SERVICE ACTION RECALL		
To: For the attention of: Please copy to:	All Dealers / MEAM The Dealer Principal The Service Manager The Sales Manager The Parts Manager Warranty Administrator Aston Martin Technician(s)	Reference: SAR 011 Issued: November 2005
Model:	DB9	
Vin Range:	A04048 – B04296 – See attached VIN list	
Subject:	ZF Automatic Transmission –Parking Pawl Glide Plate	Page: 1 of 7

SERVICE ACTION RECALL		
To:	All Dealers / MEAM	Reference: SAR 011 Issued: November 2005
For the attention of:	The Dealer Principal	
Please copy to:	The Service Manager The Sales Manager The Parts Manager Warranty Administrator Aston Martin Technician(s)	
Model:	DB9	
Vin Range:	A04048 – B04296 – See attached VIN list	Page: 1 of 7
Subject:	ZF Automatic Transmission –Parking Pawl Glide Plate

Figure 1

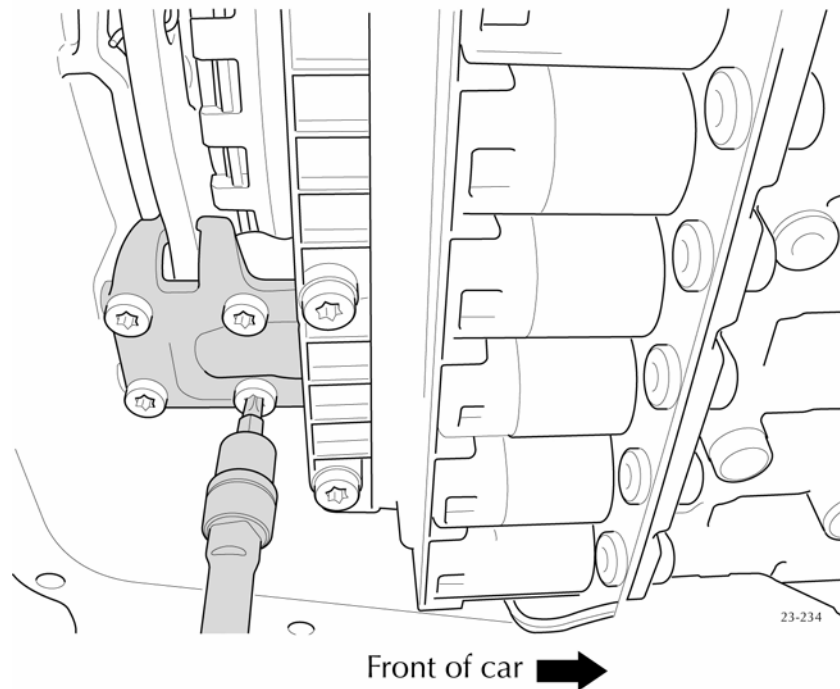
- Disconnect the oil cooler pipes from the gearbox at the thermostat and remove the pipework/thermostat assembly
- Drain the gearbox oil into a clean container for re-use, and refit the drain plug
- Remove the gearbox oil pan
- Locate and remove the Park Pawl Guide Plate by removing the four Torx screws and ease the old plate out of the gearbox, (see figure 1). Retain the displaced part for warranty return

- Fit the new Park Pawl Guide Plate and tighten the four Torx screws to 10Nm
- Check the park pawl is free to move
- Refit the gearbox oil pan, (confirm that the original gasket is clean and fully seated before refitting the gearbox oil pan) and cross torque all screws to 7-9Nm
